Council Reference: D26/317990
Contact Person: David Zabell

Shoalhaven Starches Expansion Project – MP06_0228-Mod-26
Bolong Road Bomaderry

I refer to the Department of Planning, Housing, and Infrastructure's request for comment in relation to Manildra MOD-26.

Figure 3: Extract of site plan and Part 6.1 of the Modification Report

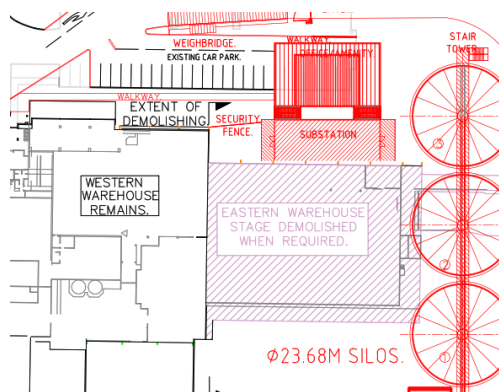
- The site plan notes that the eastern warehouse will be ‘demolished when required’ and it appears that at least a portion must be demolished for the proposed silo construction. Part 6.1 of the Modification Report indicates that the demolition will be required to construct the silos and the substation building.

- The use of ‘when’ and ‘as required’ does not provide any definitive outline for the demolition. It is unknown whether a part of the existing eastern warehouse could be demolished to permit the proposed silo construction and maintain its structural adequacy. If the existing building can accommodate partial demolition, the silo construction will not create a fire source feature to the existing warehouse building. *It is recommended* that a condition is placed in a modified consent requiring the eastern warehouse building to be demolished prior to the issue for a CC for the proposed

substation building. This would remove the need for fire safety upgrading (and the associated cost) on a building which is to be demolished at some point in the future.

Figure 4: Snip from Product Silo Site Plan Dwg No. MN7549-025

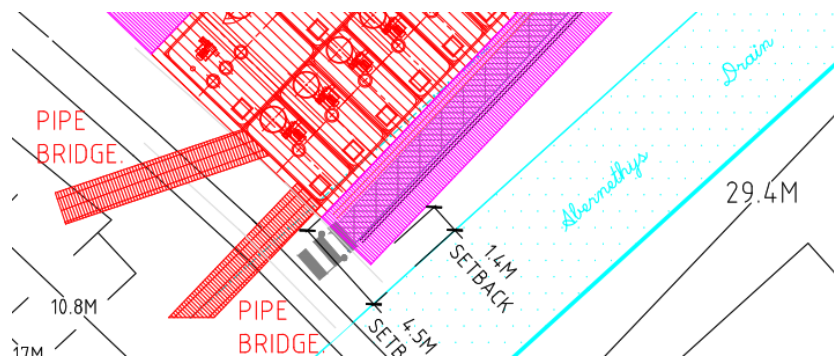
Product Silos (No. 160) – The Product Silo Site Plan (Dwg No. MN7549-025) shows the setback to Abernathy's Drain.

The aerial photography on Council's mapping appears to show the proposed building located in a right of carriageway and easement on Lot B DP 334511. It is recommended that investigation into the right of carriageway is completed to determine whether the proposed silo building can be located as proposed.

E The location of the proposed product silo building appears to be located within a right of carriageway (ROW) and easement on Lot B DP 334511. Please demonstrate that the proposed building will be located clear of any ROW or easements.

Figure 7: Plan identifying the proposed pedestrian crossing

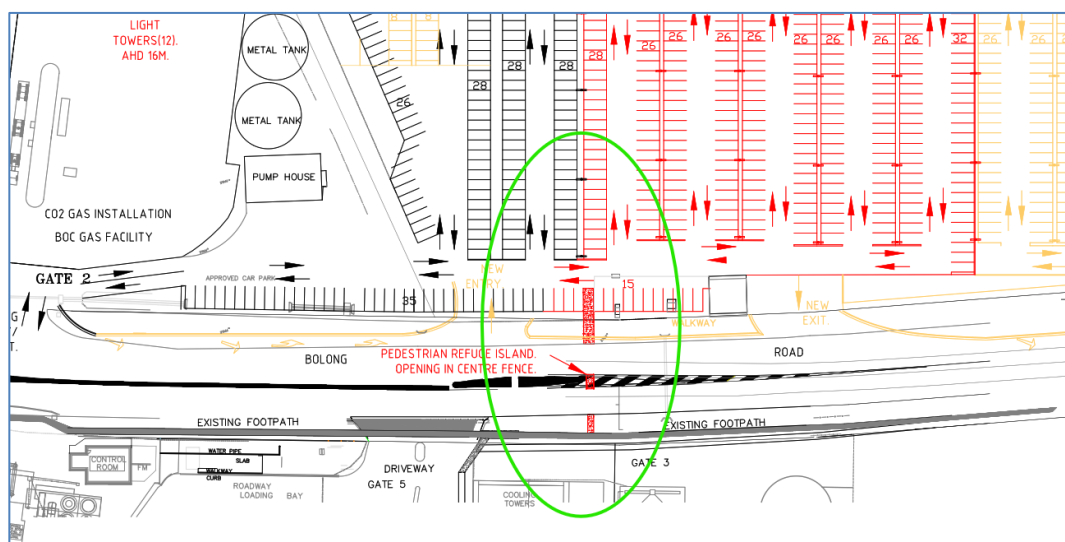
The submitted architectural plans indicate that a new crossing point will be made over the existing median island and gate.

Insufficient detail has been provided to demonstrate that the proposed crossing arrangement, including the modification of the existing median island and associated line marking, will comply with the requirements of AS 1742.10 and provide a compliant pedestrian refuge facility.

The applicant must submit revised engineering plans to SCC that indicate how the existing median strip is to be modified to a pedestrian refuge, demonstrating compliance with the above Australian Standards. A sight distance audit for SSD of approaching vehicles must also be considered, in accordance with Austroads Guidelines.
